*Department of Nuclear Engineering*

*Department of Nuclear Engineering***REVIEW OF TECHNICAL SPECIFICATIONS**

LICENSE NUMBER R-102  
TECHNICAL SPECIFICATIONS  
FOR  
THE UNIVERSITY OF NEW MEXICO AGN-201M REACTOR  
SERIAL NUMBER 112  
DOCKET NUMBER 50-252  
REVISED NOVEMBER 2014

Figure 1

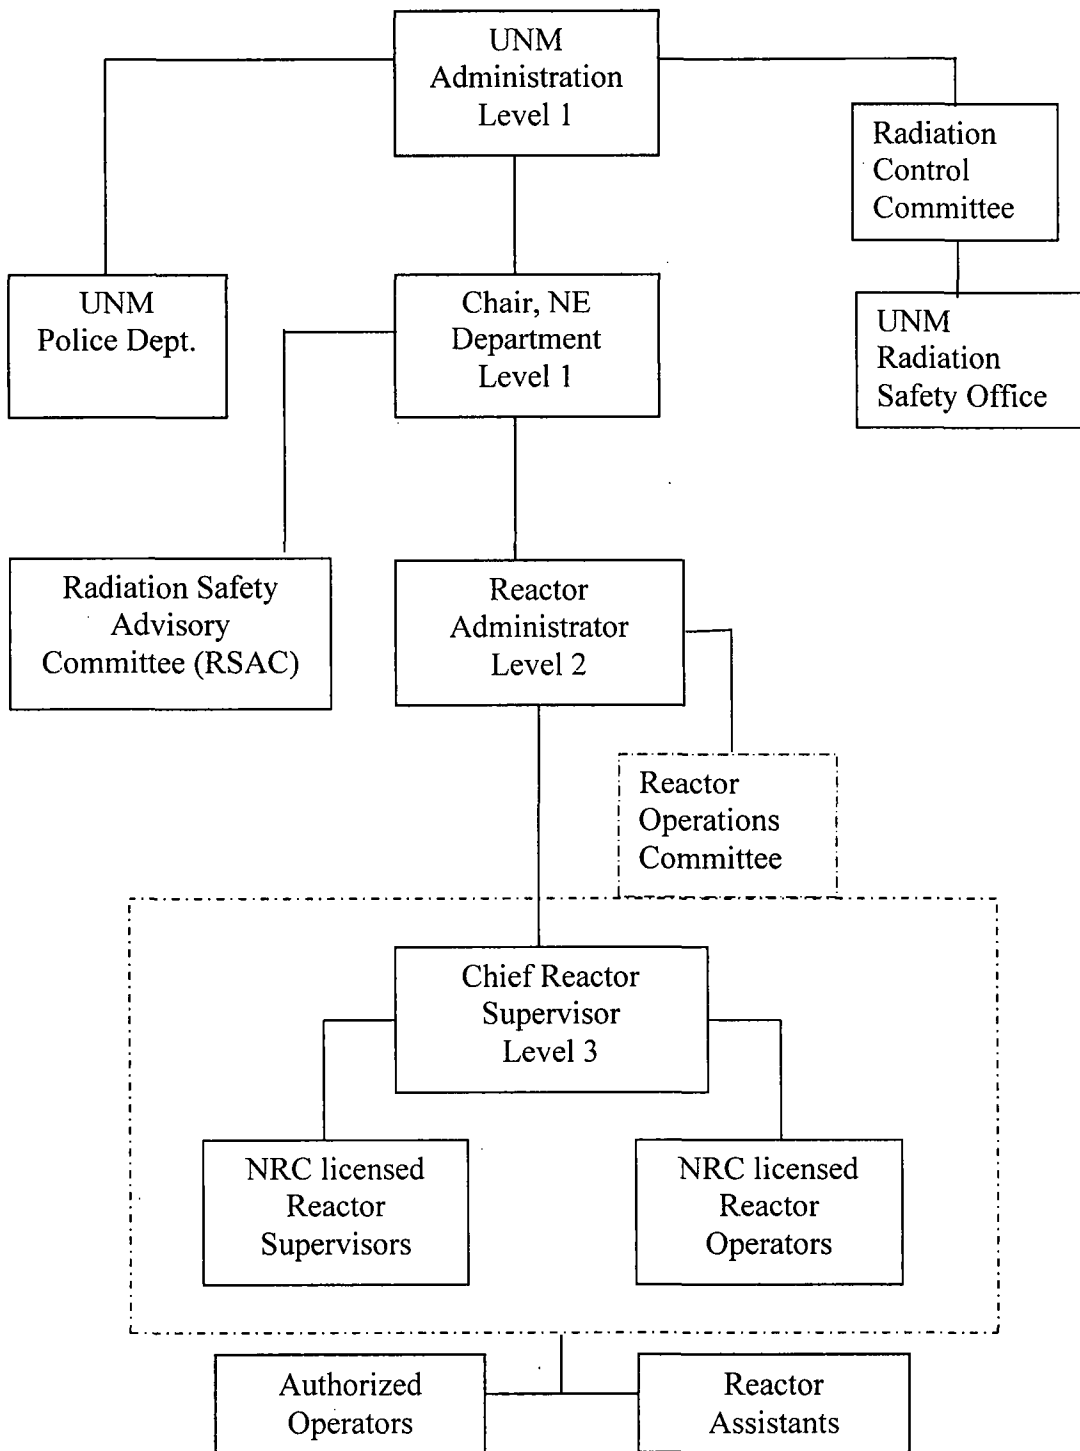
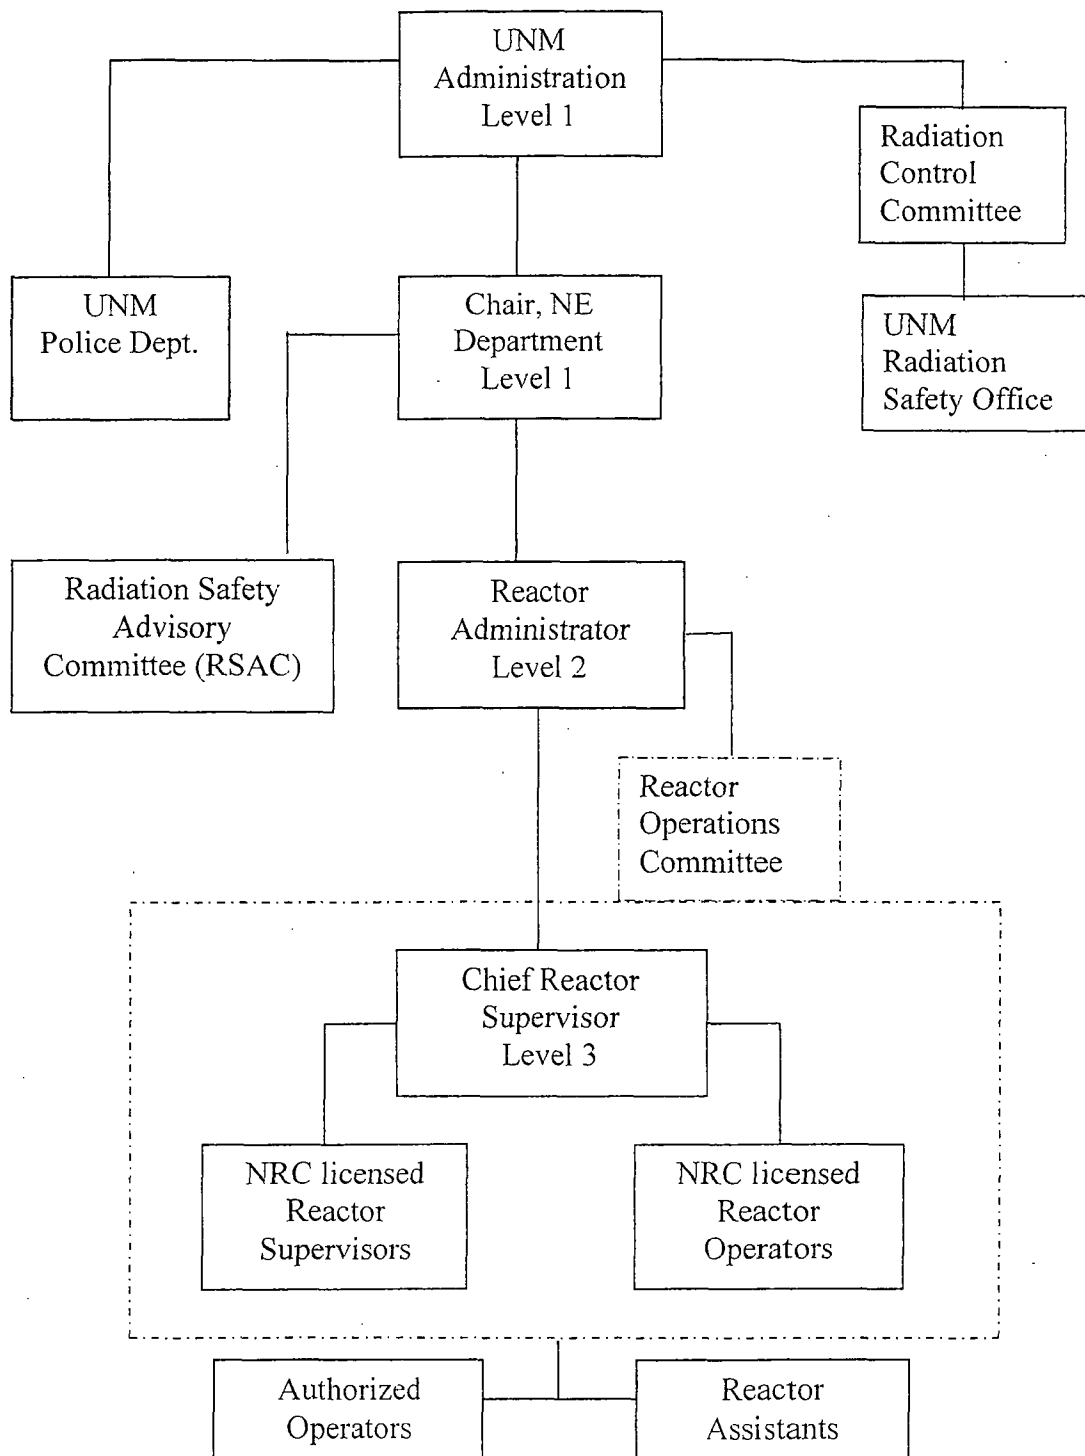
Due to the split in departments, department name and title corrections were required in Section 6.1 and in Figure 1.

Pg. 23, Fig. 1 – changed the title of the Chair to Chair, NE Department, and removed the NE Lab Supervisor as this position has no direct responsibility to the Reactor.
